Project	<b>IEEE 802.16 Broadband Wireless Access Working Group</b> < <a href="http://ieee802.org/16">http://ieee802.org/16</a> >	
Title	<b>Architecture clarification and Coexistence Protocol messages cleaning</b>	
Date Submitted	<b>2005-09-13</b>	
Source(s)	Chi-Chen Lee, Hung-Lin Chou, Industrial Technology Research Institute, Computer and Communications Research Labs, Taiwan Bldg. 11, 195 Sec. 4, Chung Hsing Rd. Chutung, HsinChu, Taiwan 310, R.O.C.	Voice: +886-3-5914579 Fax: +886-3-5829733 mailto: <a href="mailto:jjlee@itri.org.tw">jjlee@itri.org.tw</a>
Re:	Call for Contributions: IEEE 802.16 License-Exempt Task Group, IEEE 802.16h-05/018	
Abstract	Propose the architecture of storage of identification information and Coexistence Protocol.	
Purpose	Information.	
Notice	This document has been prepared to assist IEEE 802.16. It is offered as a basis for discussion and is not binding on the contributing individual(s) or organization(s). The material in this document is subject to change in form and content after further study. The contributor(s) reserve(s) the right to add, amend or withdraw material contained herein.

## Architecture clarification and Coexistence Protocol

[Figure 14. Classification of 802.16 LE network architecture](#)

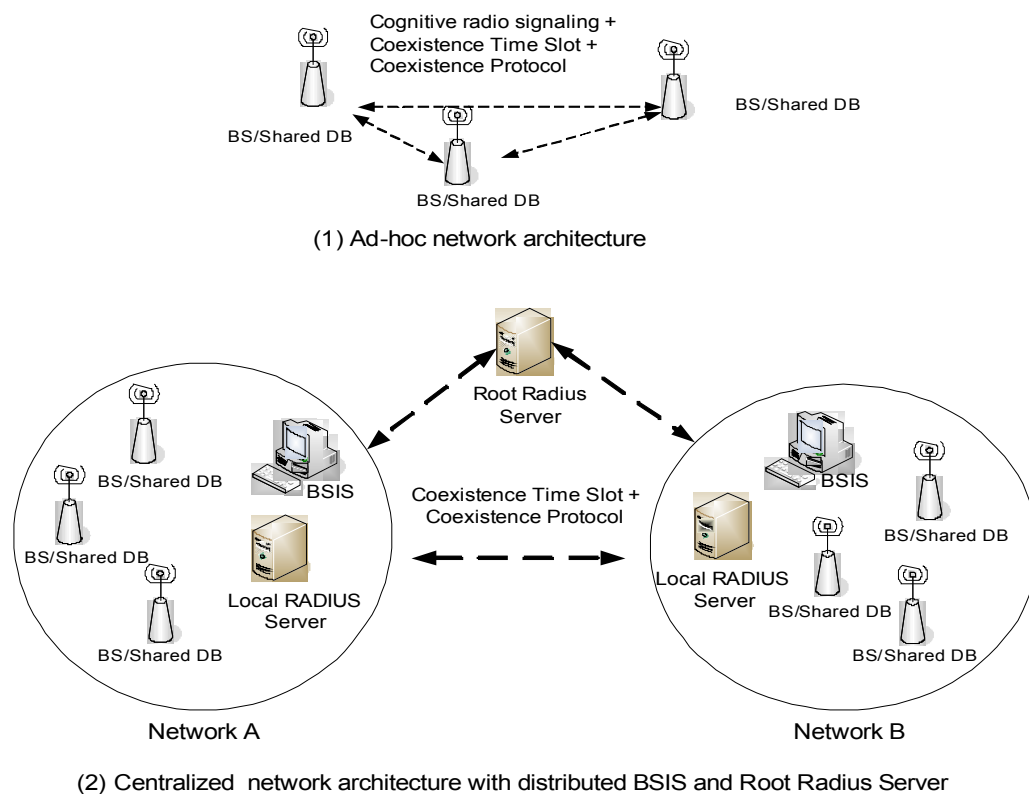
[Change Figure 14 as following]

[Figure 14 shows the classification of IEEE 802.16 LE inter-network communication architecture:](#)

Figure 12. Initialization procedures — BS

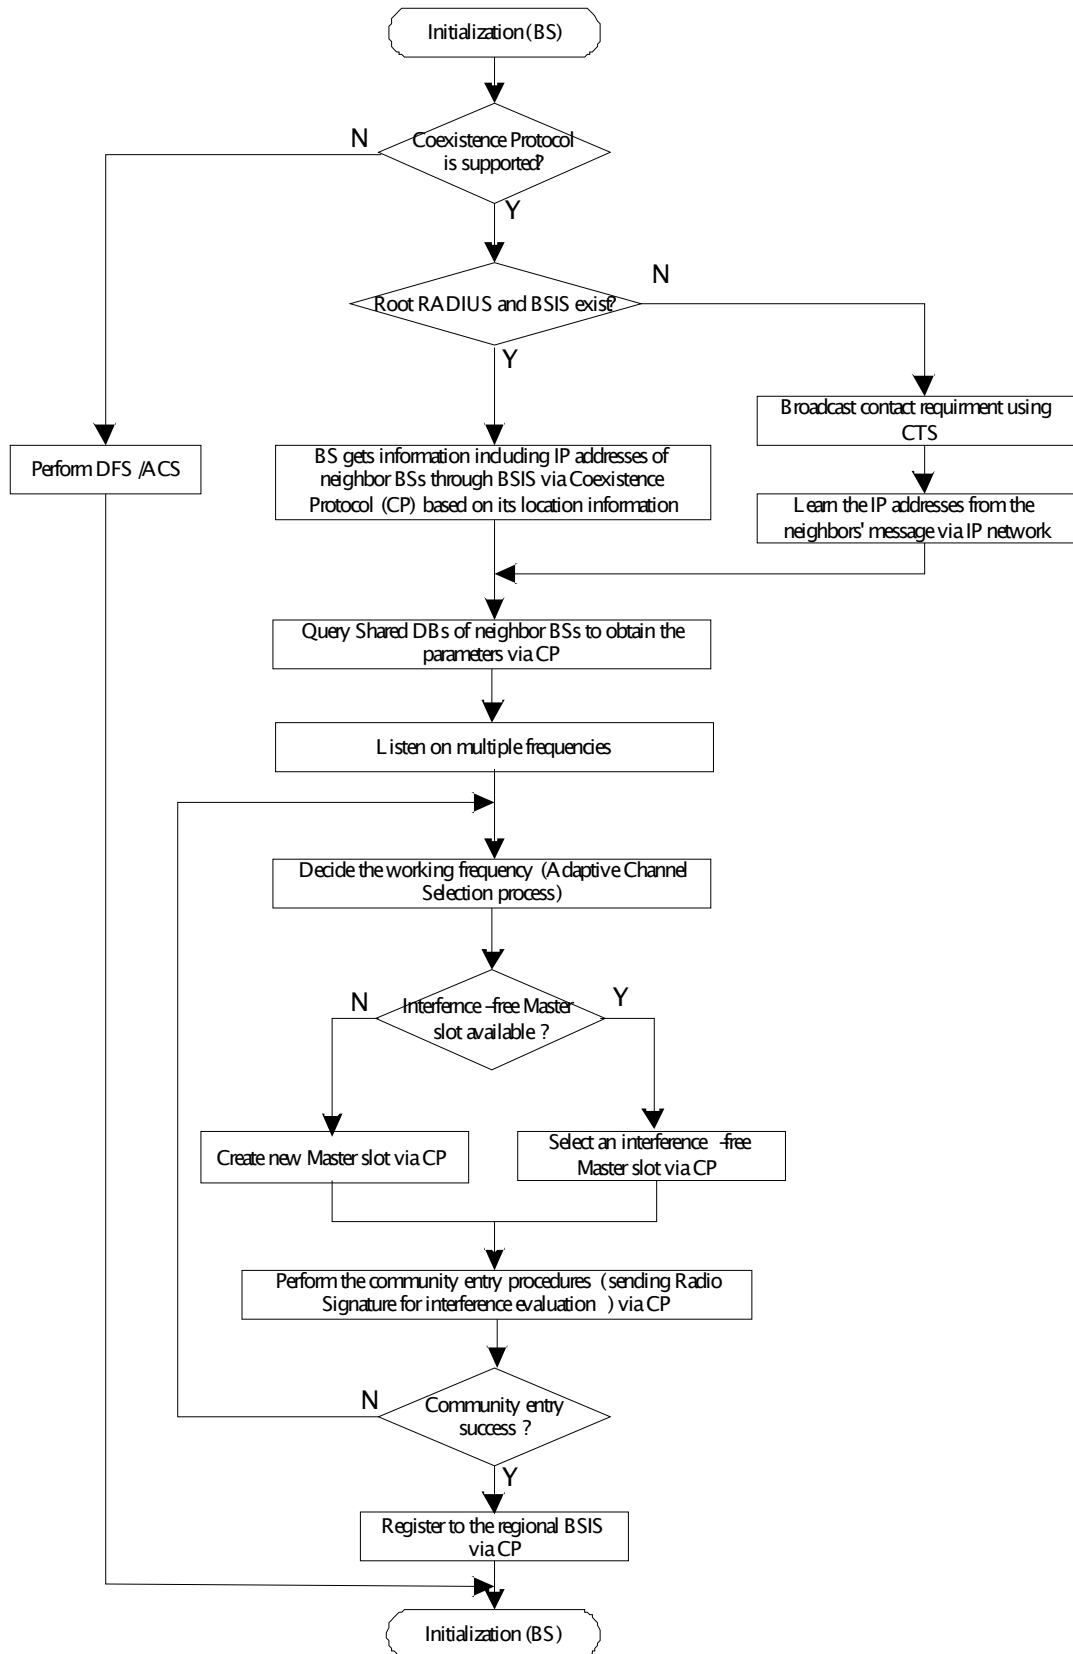
*[Replace Figure 12 as following]*
